ACCESSION NBR: 8603200092 DOC. DATE: 86/03/14 NOTARIZED: YES DOCKET #
 FACIL: 50-410 Nine Mile Point Nuclear Station, Unit 2, Niagara Moha 05000410
 AUTH. NAME AUTHOR AFFILIATION
 MANGAN, C. V. Niagara Mohawk Power Corp.
 RECIP. NAME RECIPIENT AFFILIATION
 ADENSAM, E. G. BWR Project Directorate 3

SUBJECT: Forwards revised FSAR pages re QA program. Program will be fully effective for all QA activities upon completion of 100 h warranty run. Info will be incorporated into Amend 26 to FDSAR.

March 14, 1986
(NMP2L 0659)

Re: Nine Mile Point Unit 2
Docket No. 50-410

FIGURE 17.1-2

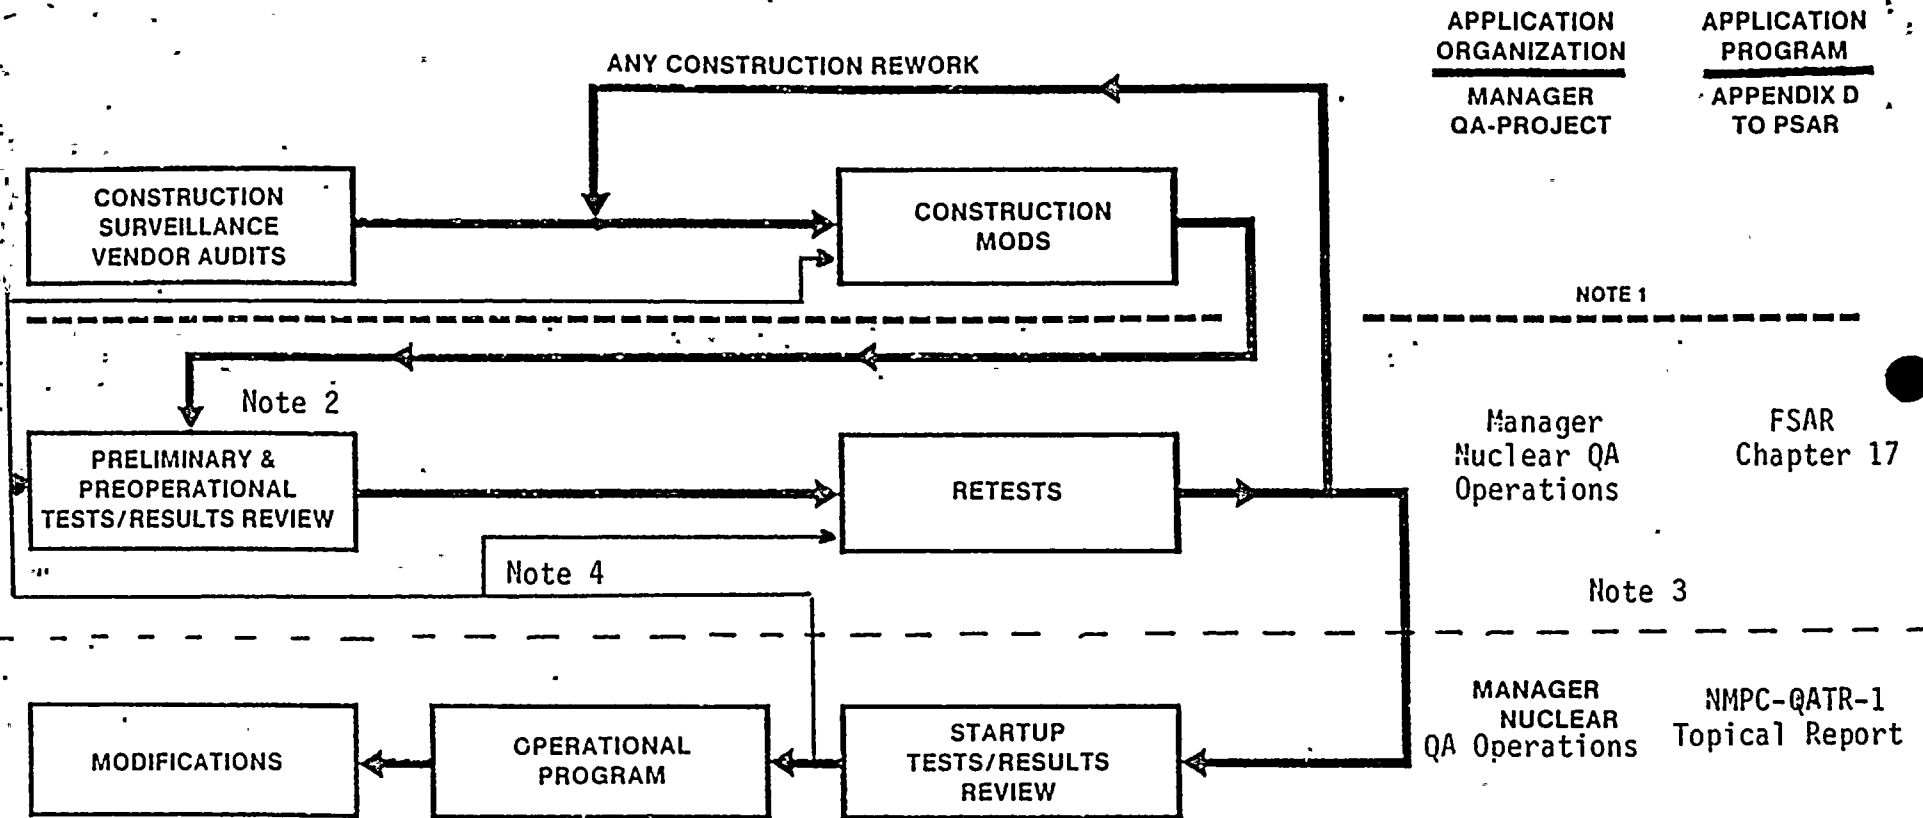
Appendix D to the Unit 2 PSAR, as updated in accordance with 10CFR50 submitted under separate cover, defines the NMPC QA program used for the design and construction phase of Unit 2. This section describes the QA program to be used during the preliminary and preoperational testing phase of NMP2 including those preoperational/acceptance tests and retests performed in the period starting with fuel load and ending with the 100 hour warranty run. Startup testing and operational activities subsequent to preoperational testing will be governed by the Niagara Mohawk Power Corporation Quality Assurance Program Topical Report Nine Mile Point Nuclear Station Units 1 and 2 Operations Phase, NMPC-QATR-1, Revision 1. Figures 17.1-1 and 17.1-2 depict the organizational structure and lines of responsibility for the three program phases. Figure 17.1-2 also shows that during the interval between fuel load and full power commercial operation, all three programs will be employed to handle any components or systems requiring reworking or retesting by the construction and preoperational test groups at NMP2. Following the 100 hour warranty run at full power, the PSAR Appendix B and FSAR Chapter 17 programs will be replaced by the NMPC-QATR-1, Revision 1, Topical QA program.

1. THIS LINE DESIGNATES THE APPLICABLE QA MANAGER AND QA PROGRAM
2. SITE AUDITS OF THE INITIAL TEST PHASE ARE PERFORMED BY THE MANAGER OF QA PROJECTS IN ACCORDANCE WITH THE CHAPTER 17 QA PROGRAM FOR AN INTERIM PERIOD UNTIL FUEL LOAD
3. This line designates that activities subsequent to acceptance and preoperational testing are governed by QATR-1, Rev. 1.
4. Any required construction rework or retest under the acceptance/preoperational testing program are governed by the applicable QA Program.
